FORD:

2015-2016 F-250, F-350, F-450

This article supersedes TSB **15-0106** to update the Issue Statement, Service Procedure and Part List.

TSB 16-0041 (Continued)

Figure 1 - Article 16-0041

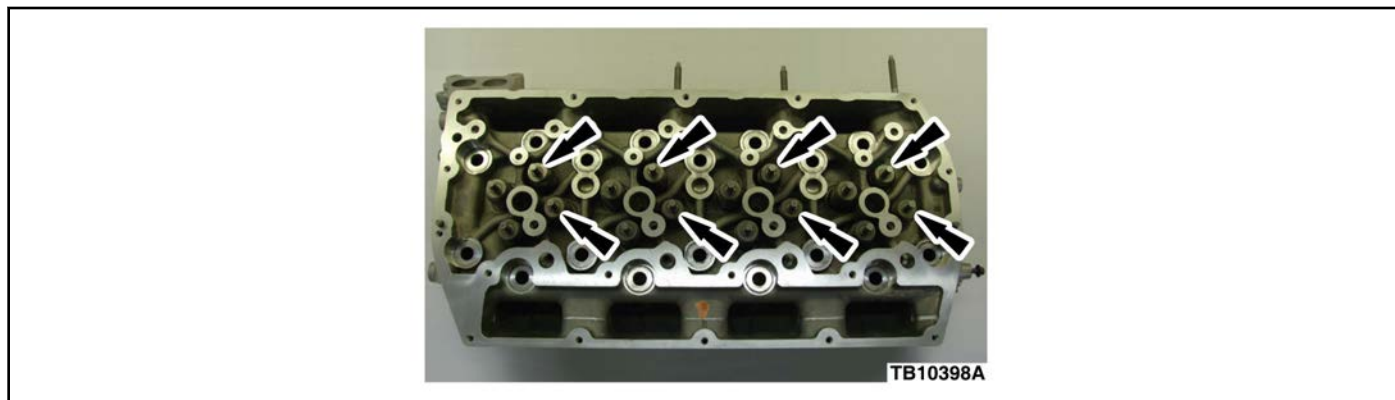
1. Reprogram the powertrain control module (PCM) to the latest calibration using Integrated Diagnostic System (IDS) release 99.03 or higher. Make sure you are connected to the internet when entering module programming to obtain the latest updates. Calibration files may also be obtained at www.motorcraftservice.com
2. Did the customer indicate the message center displayed a Cleaning Exhaust Filter message prior to the concern?
 - a. Yes - proceed to Step 3.
 - b. No - proceed to Step 6.
3. Remove the left cylinder head. Refer to Workshop Manual (WSM), Section 303-01.
4. Replace all eight (8) exhaust valves and valve seals. Refer to WSM, Section 303-01. (Figure 1)
